### **NOTICE OF DATA INACCURACY**

## INSPECTION REPORT

Electrical Corporation:	San Diego Gas and Electric Company
Report Number:	PAD_SDGE_SIS_20251008_1332
Date of Inspection:	October 8, 2025
City and/or County of Inspection:	Valley Center, San Diego County
Inspector:	Samuel Isaiah
WMP Year Inspected:	2025
Quarterly Data Report (QDR) Referenced:	Quarter 2 (Q2)
Inspection Selection:	Energy Safety viewed the contents of the Q2 QDR and performed an analysis that resulted in the selection of the WMP initiatives and locations referenced in this report.
Relevant WMP Initiative(s):	8.1.2.1 – Covered Conductor Installation (WMP.455)
Inspection Purpose:	Assess the accuracy of San Diego Gas and Electric Company's QDR data, completeness of its work, and performance of WMP requirements.

**GImg1:** Overall Structure

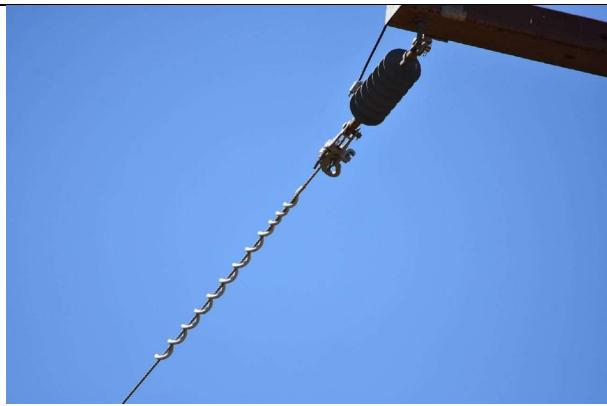
On Pole ID P612194, Grid Hardening ID P612194\_0350-L-CC\_83638 at 10562-10798 Camino del Venado, Valley Center, CA, 92082, 33.3146668789374, -117.102580, the inspector observed that no covered conductor was installed at this location. The inspector's observation is documented in Data Inaccuracy 1 photographs, which are attached to this report as IA1Img1, IA1Img2, IA1Img3 and IA1Img4.

1. SDG&E's 2025 Q2 QDR identified that WMP Covered Conductor (8.1.2.1) work was complete at the inspection location.
2. Covered conductor was not installed.
